Determination 2009/32

The code compliance of the foundations to a relocated house at 146A Barrack Road, Mount Wellington, Auckland

- 2.4.2 An approximate plan (with gridlines A to F indicating bearer positions) is shown below:

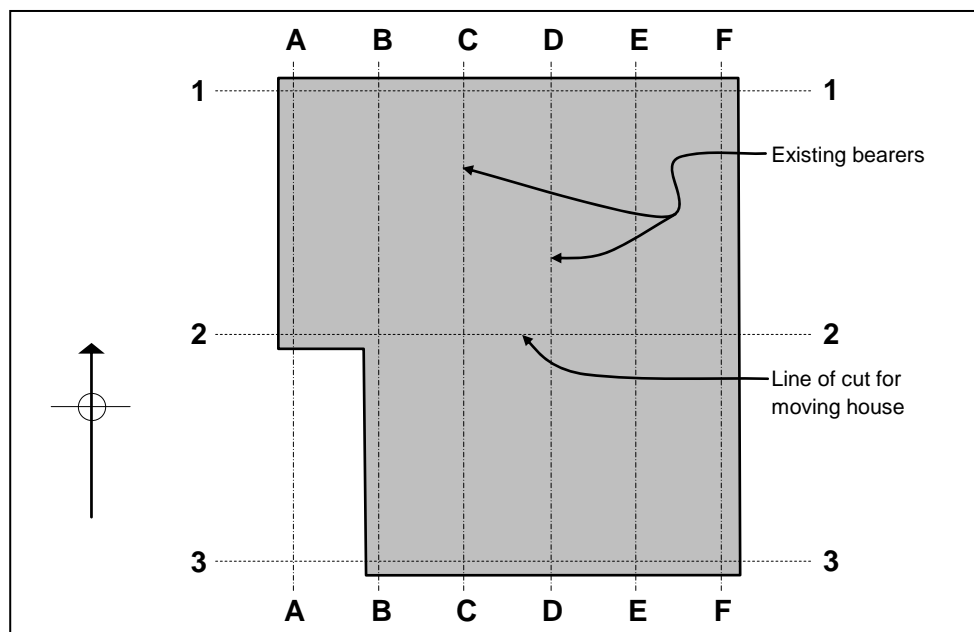
6.3.4 The expert assessed the foundations against the requirements of NZS 3604 (refer paragraph 2.4.2 for grid line references). The expert noted that the original bearers were retained, with new bearers added along grid lines A and F.

- although piles are generally at 1300mm centres maximum, a pile is missed at the north end of grid E resulting in spacings beyond the maximum
- some piles are not centred on the concrete footings

- the bearers are not fixed to the piles
- the bearer on grid line A is cantilevered by 900mm, which exceeds the maximum cantilever of 300mm specified in section 6.12.4

- the original bearers at grid lines A and F are suspended from the floor joists, and confirmation is needed whether the resulting cantilever complies with Table 7.2, considering the span of the roof

- the bearers at grid lines D and E are out of line with the piles, and short lengths of smaller secondary bearers are used to achieve alignment, but these may not be sufficient to transfer loads adequately

- some joints in the bearers are not centred over the piles to provide a 45mm landing as required by section 6.12.7, and there are no connectors across the joints

- where the original bearers were cut for moving the house, they have not been reconnected adequately, relying on a timber plate nailed to the old and new joists on either side of the cut which is not adequate to resist earthquake loads

- 9.1 The authority should withdraw its proposed scope of work and develop a revised proposal that includes rectification of the items outlined in paragraphs 6.3.5, 6.3.6, 8.3.1, 8.3.2 and 8.3.4. In this respect I note the expert’s comments that further investigation is needed to confirm certain aspects of the work. Any outstanding items of disagreement can then be referred to the Chief Executive for a further binding determination.
